CSC-10040386-2354

Subject: E033, Campaign to verify coolant filter torque

Location of coolant filter depicted

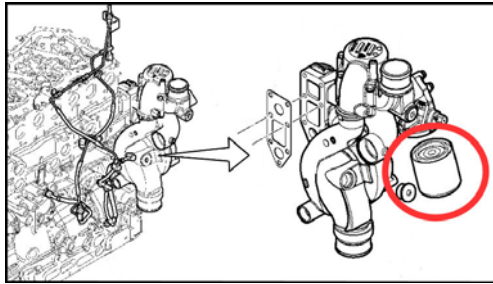
Kenworth has identified that some vehicles may have been manufactured with inadequate torque applied to the engine coolant filter. The vehicle listed by VIN on this letter is part of the potentially affected population and Kenworth would like the opportunity to inspect and take corrective action as appropriate. Left uncorrected, inadequate filter torque may result in the loss of coolant resulting in potential engine overheating.

Proper torque can be achieved by hand tightening the filter in the clockwise direction an additional $\frac{1}{2}$ to $\frac{3}{4}$ revolutions beyond the snug position (loosened counter clockwise to the point of coolant weeping).
